TEXAS COMMISSION ON ENVIRONMENTAL QUALITY

Name of Project: **Central Texas Pain Center**; Located at 213 Hunter's Village; New Braunfels, Texas

Type of Plan: Request for Technical Clarification of an Approved **Water Pollution Abatement Plan**; 30 Texas Administrative Code (TAC) Chapter 213, Edwards Aquifer

Re: Response to TCEQ Comments dated June 23, 2014
Edwards Aquifer, Comal County
NAME OF PROJECT: Hunter's Creek Business Park, Lot 11B2; Located on the north side of Hunter's Village, approximately 150 feet northwest of the intersection of Hunter's Village and Oak Run Parkway; New Braunfels, Texas.
TYPE OF PLAN: Request for Approval of a Water Pollution Abatement Plan; 30 Texas Administrative Code (TAC) Chapter 213 Edwards Aquifer;
Additional ID No. 13-14052001; Investigation No. 1172139; RN107296733;

DATE	DESCRIPTION	REVISED PER TCEQ COMMENTS
06/23/14		06/23/14
DRAWN BY: D.G. III		
CHECKED BY: D.D.P.		
DATE: JUNE 2014		
JOB NO.: 1401.02		
P-1

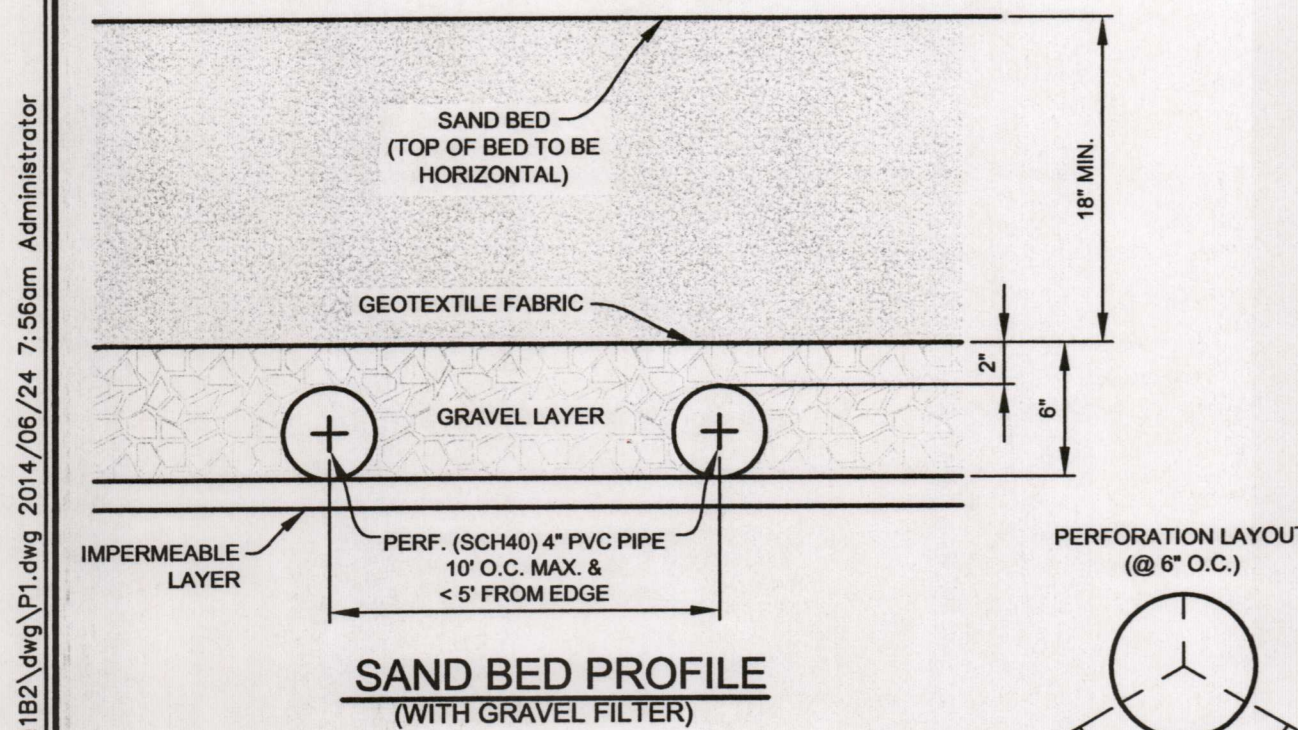
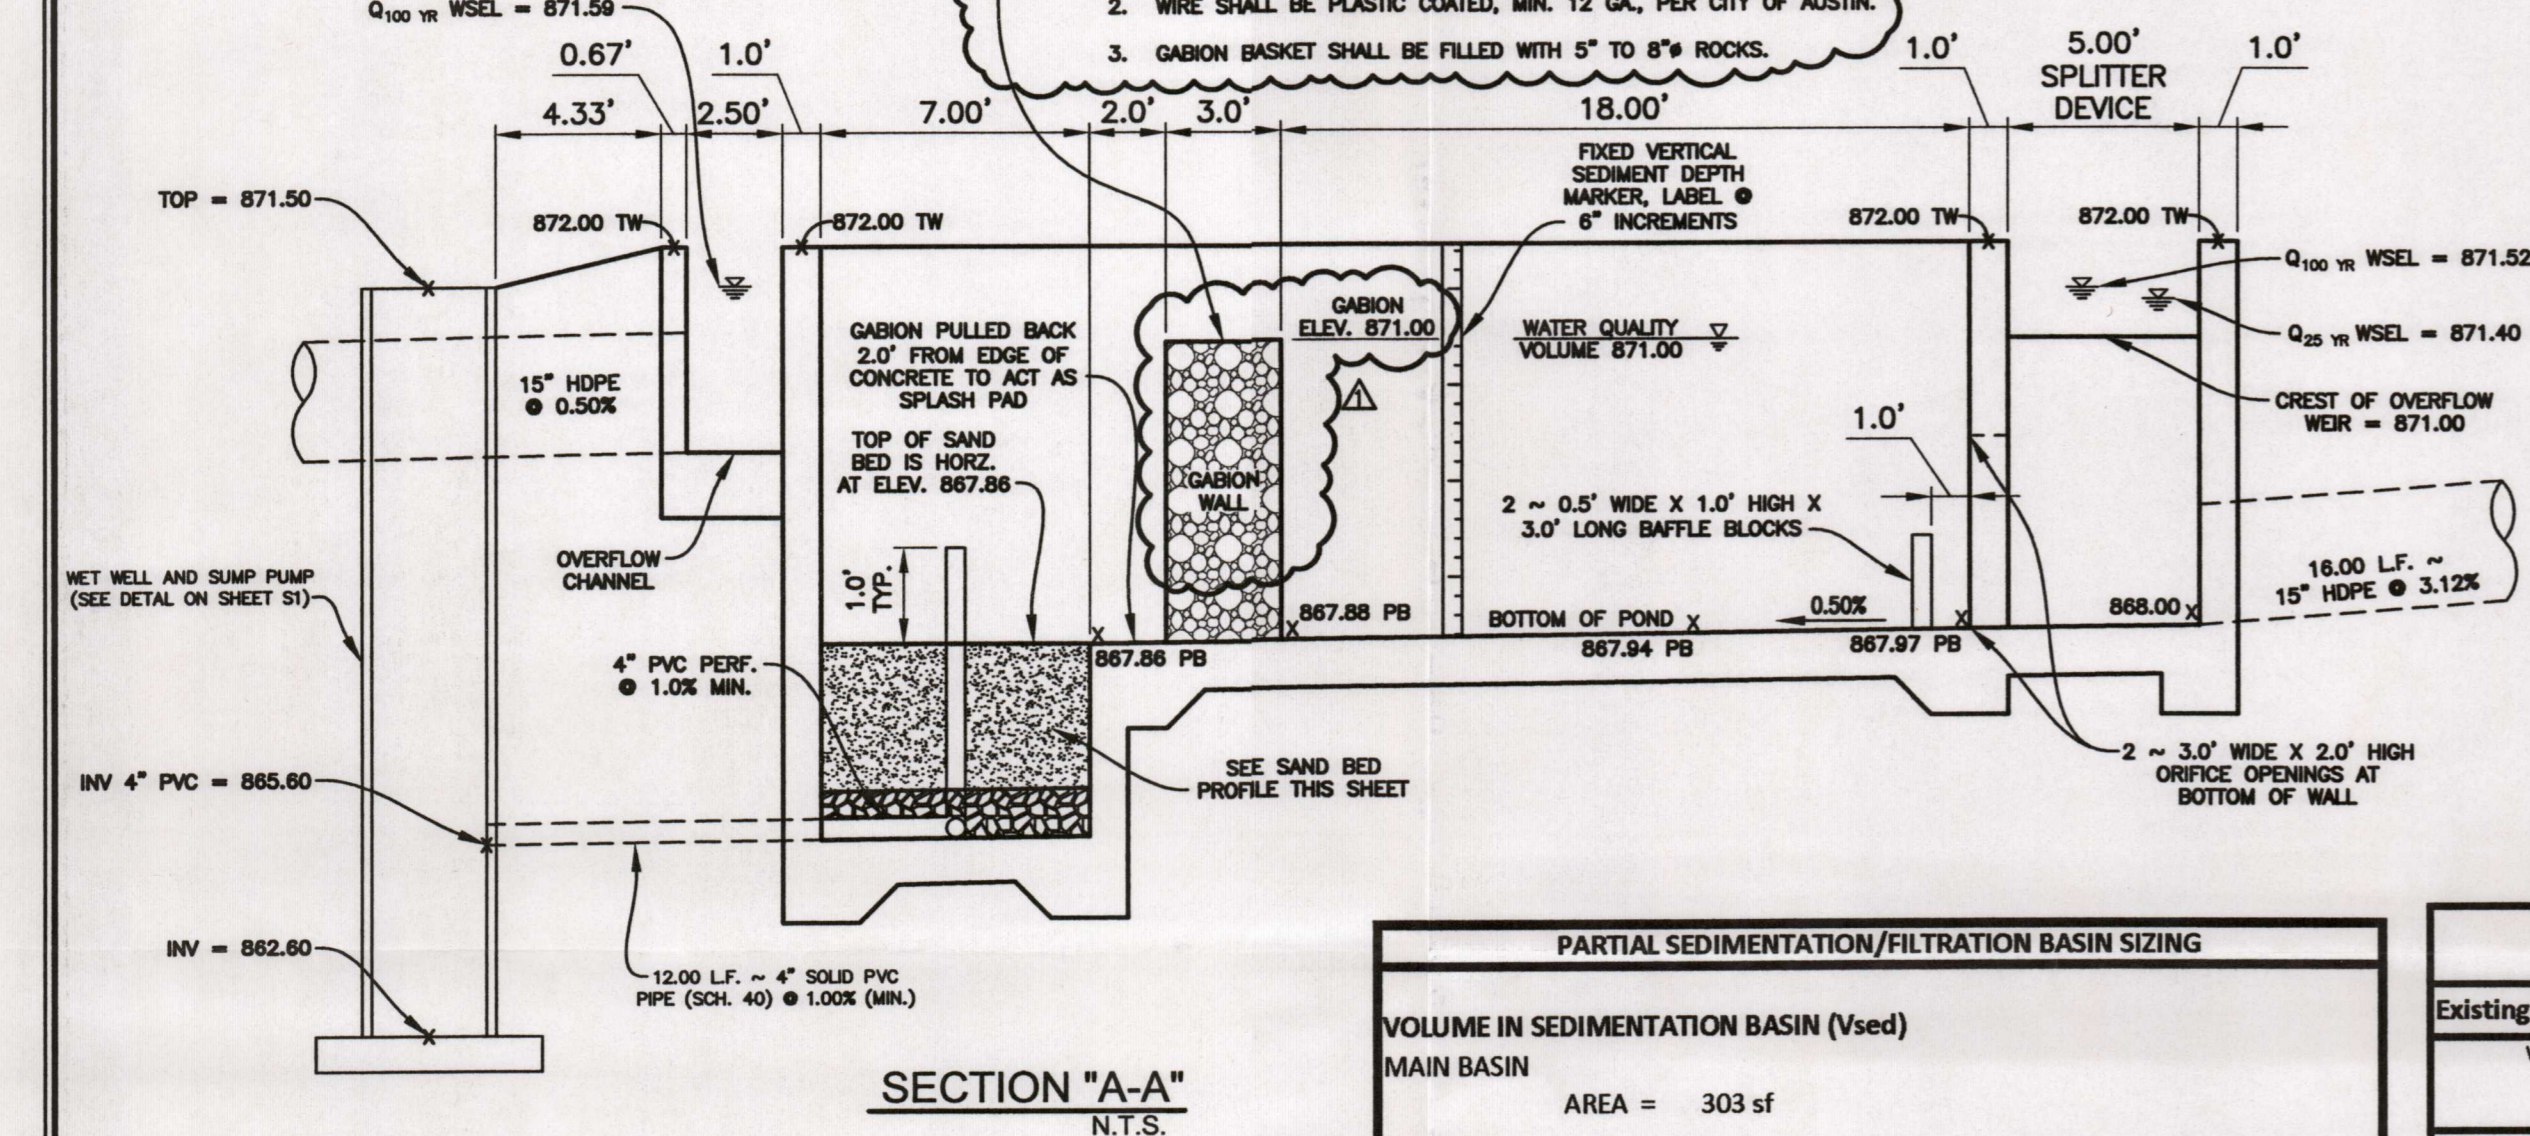
| 1 | A wet well/sump pump detail has been added to S1 with notes taken from the provisions for the alarm and wet well found in TGM (RG-348) 3.4.3. |
| 3 | The gabion wall height has been modified to match the height of the water quality volume. |

SITE PLAN FOR HUNTER'S CREEK BUSINESS PARK LOT 11B2 - MEDICAL OFFICE NEW BRAUNFELS, TEXAS

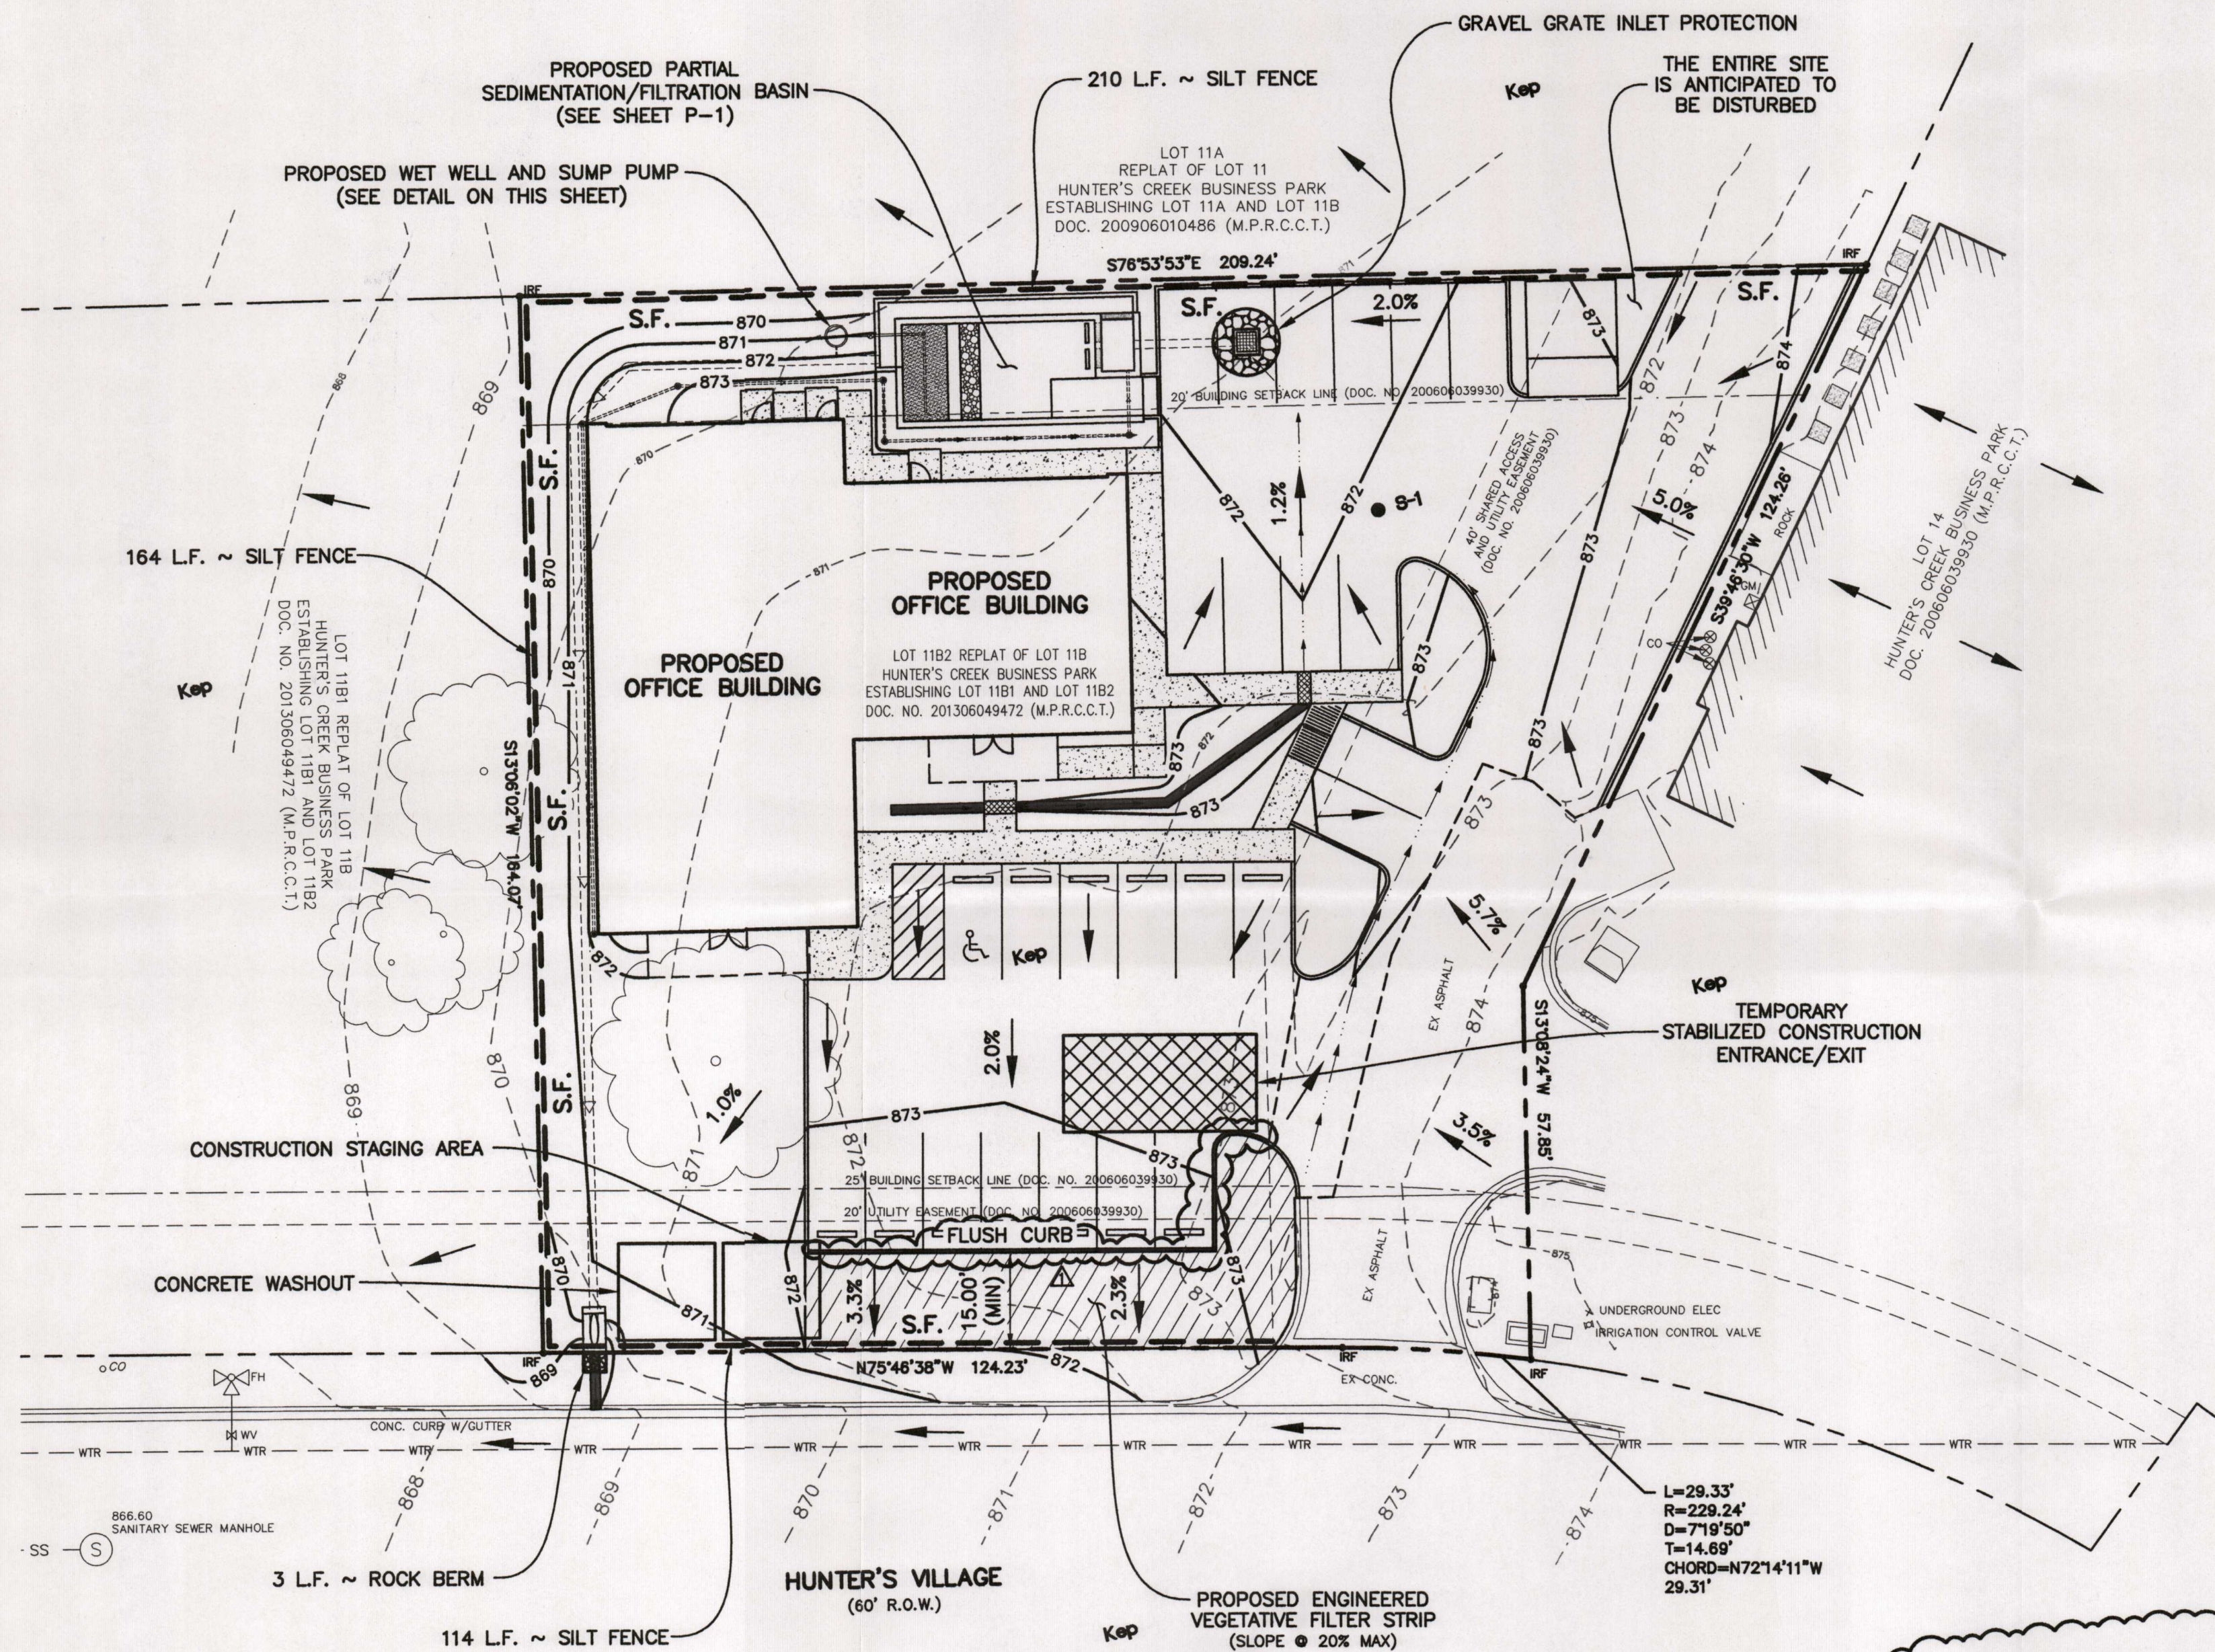
| 2 | The proposed curb for this area is a flush curb which will allow runoff from the parking area to sheet flow onto the EVFS. The flush curb has been labeled. |
